Revised Landscaping Proposals

Groveside School
(Former Hamilton Academy)
40 Christchurch Road
Reading
RG2 7AY

Design and Access Statement

February 2026

North-West Boundary

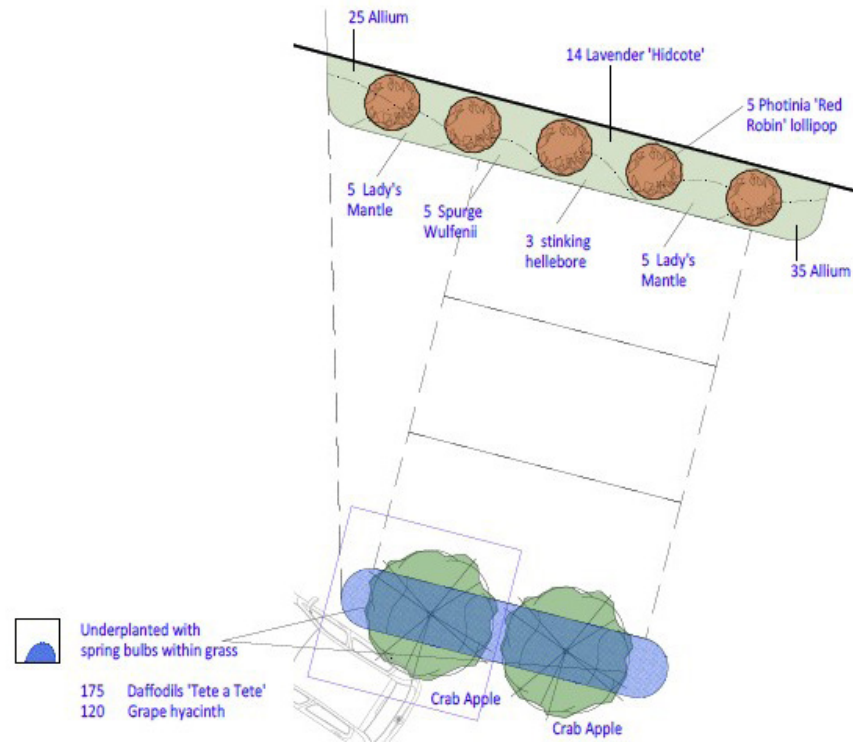
Species proposed remain unchanged.

Crab Apple removed due to restriction of planting area.

Site Boundary extended, area outside of gates, adjacent to footpath, to receive planting to soften the appearance from the street. Three Viburnum are proposed in response to pre-app advice suggesting that Red Robin would not suitably contribute to the schemes wildlife value. In addition, one Bird Cherry Tree has been proposed to counteract the loss of trees elsewhere.

The only service clash is with the BT box, which has led to the removal of one tree that was shown in the Pre-App

North-East Boundary

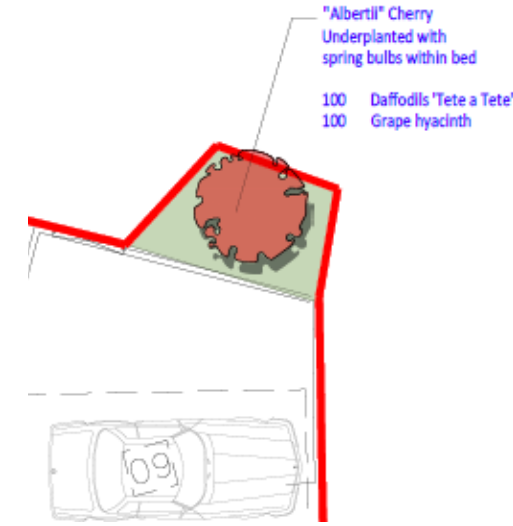
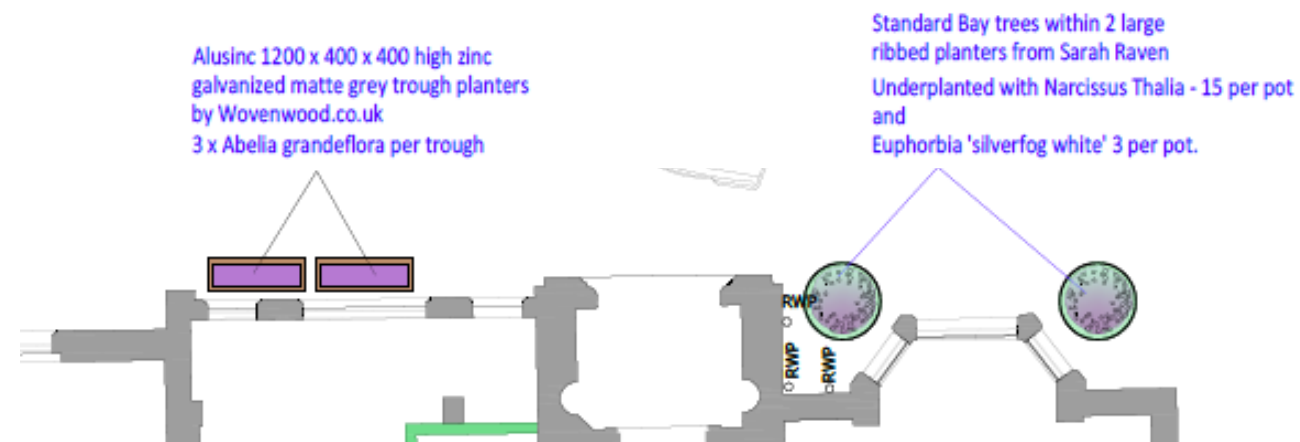
Crab apples and planting moved to outside the boundary gates due to risk of clash with cars and to soften the appearance from the street.

Additional planting added to the eastern side of the vehicle access.

Bay trees and planters added to the front of school to help mitigate the loss of planting from adjacent to the fence lines to the north and east. The planters for these bays will be sized in accordance with the designers requirements to ensure reasonably sized trees are accommodated in this area.

There are no service clashes indicated in either area at the front, however, further investigation will be required during the excavation.

Adjacent to Pavilion Ramp

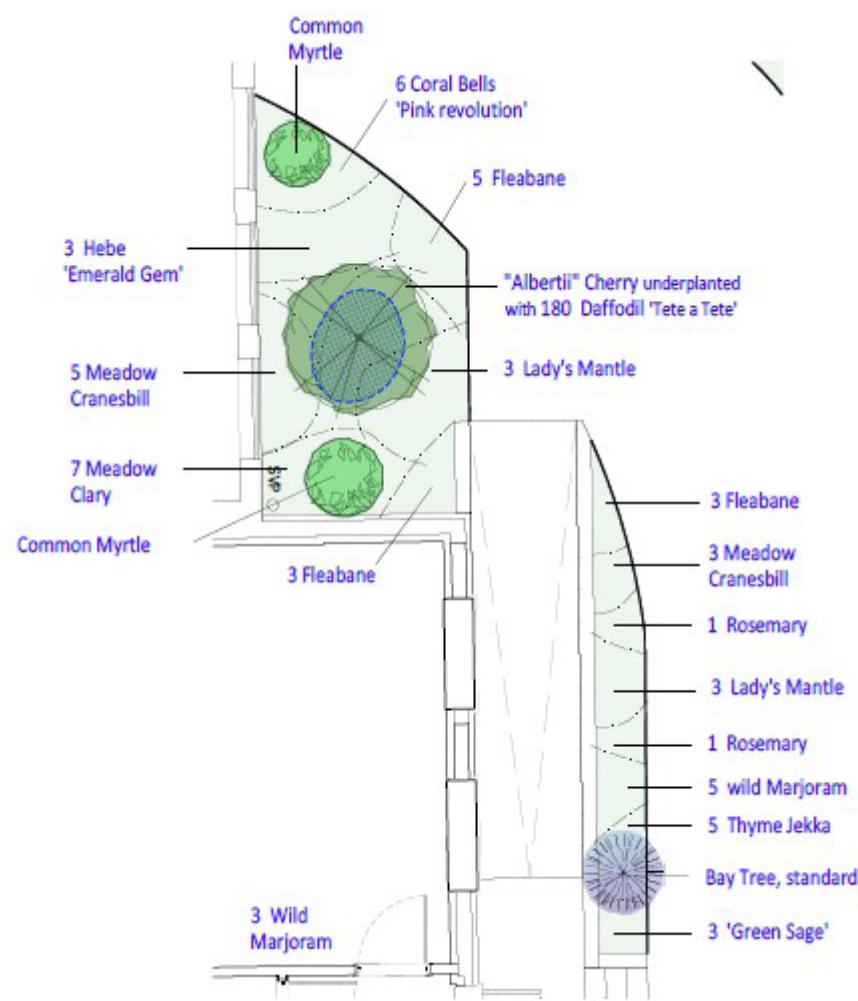
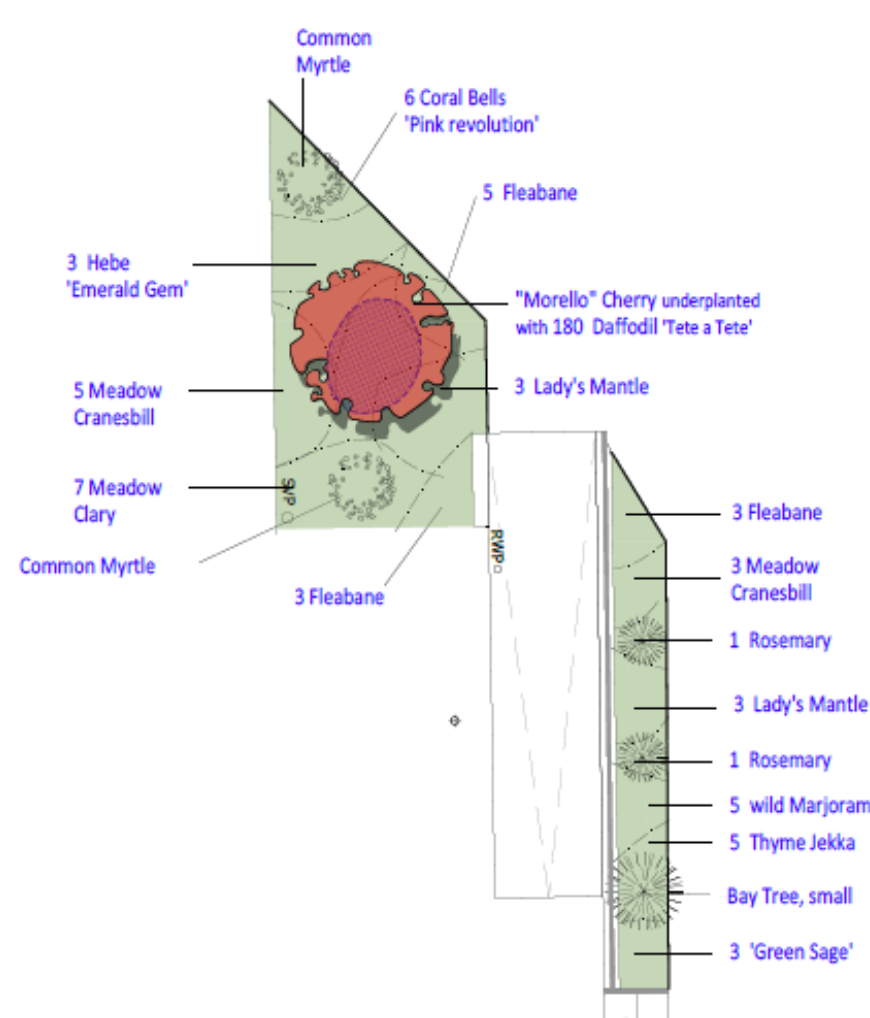
The areas at the top and end of the pavilion area are as proposed within the planning submission, with one viburnum removed from the end to prevent overcrowding.

Main Pavilion Section

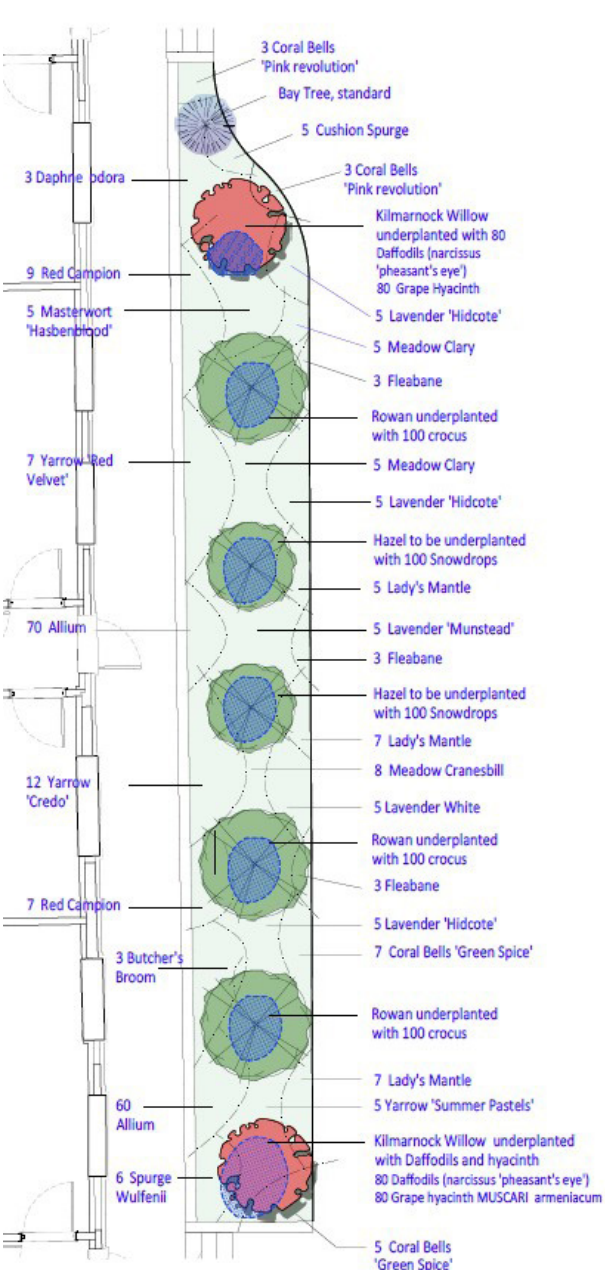
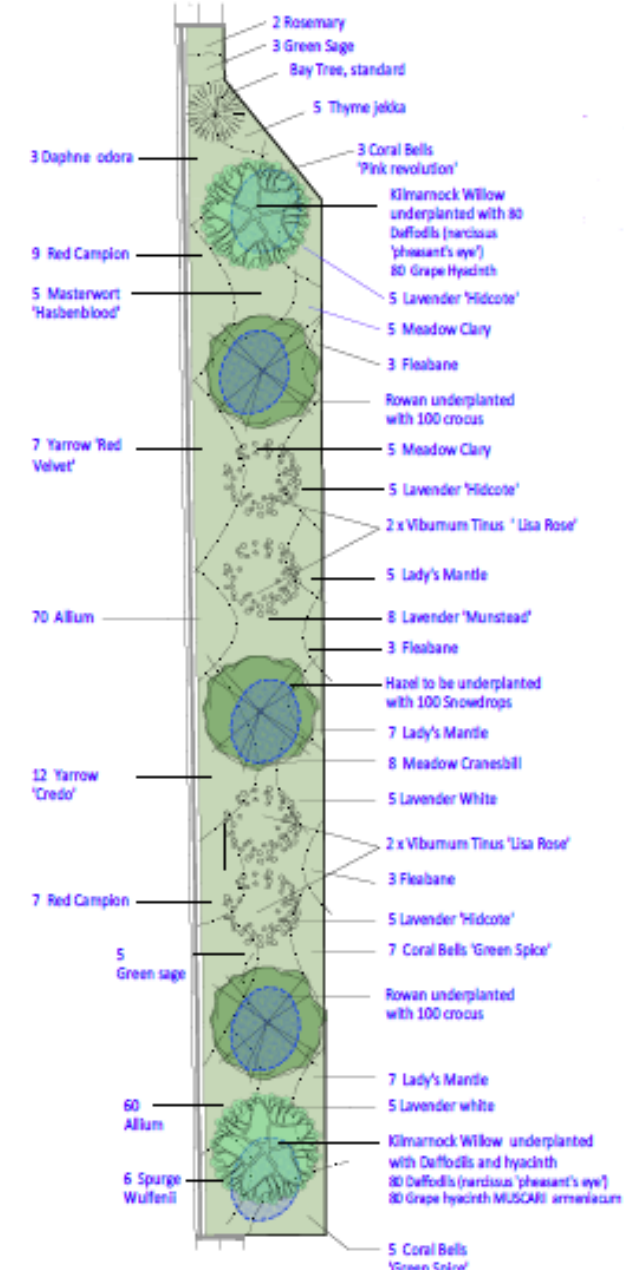
The main pavilion section retains the same area and majority of planting. One Hazel and one Rowan removed to prevent overcrowding. Additional trees are present elsewhere in the scheme to mitigate this reduction.

South-West Boundary

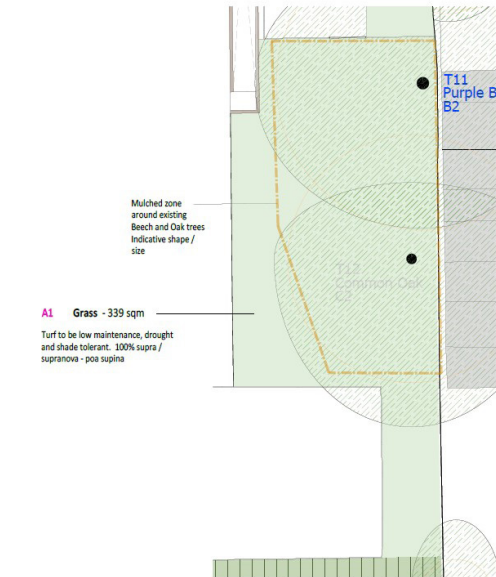
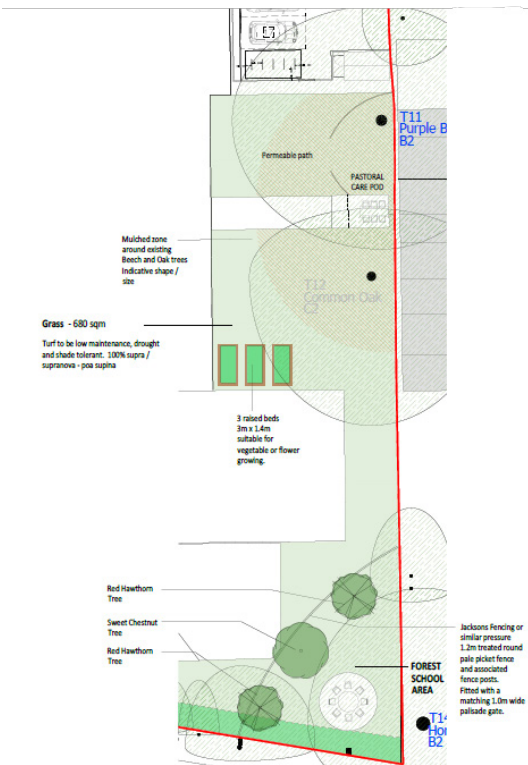
At the rear of the site we are proposing additional planting in the form of the Chestnut and Red Hawthorn trees as well as planters for vegetable or flowers. This area is planned as a 'Forest School' area, where the children can learn in the outside. The Chestnut will be maintained at a relatively small size so as not to dominate the first school area.

Ramp Adjacent

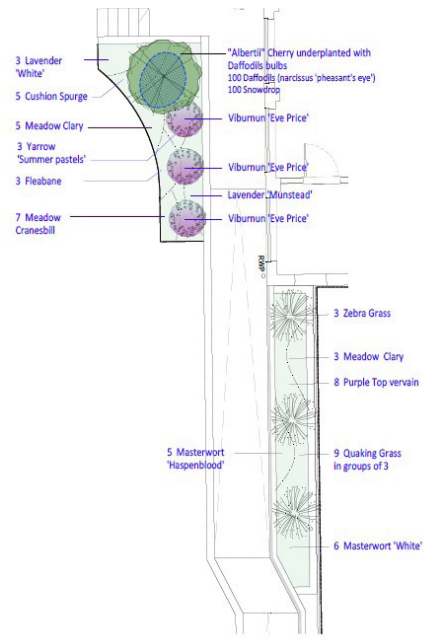
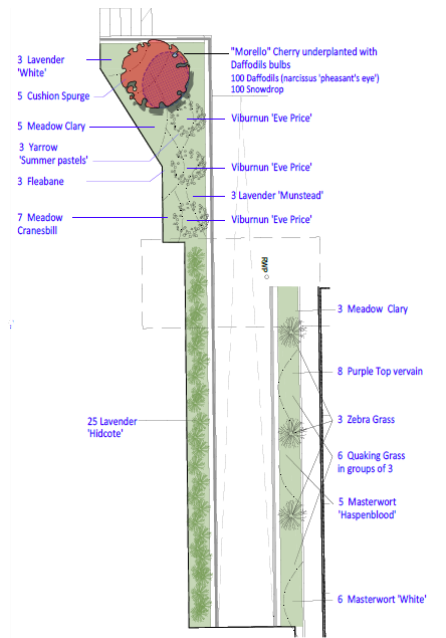
Adjacent to the altered ramp, there are no proposed changes. The altered shape of the ramp has allowed for a large section of lavender to be added.

A query was raised by the Natural Environment Team regarding the planting adjacent to the ramp. We believe the photo provided indicates an area to the south of what is proposed and a slight misunderstanding. The area remains the same.
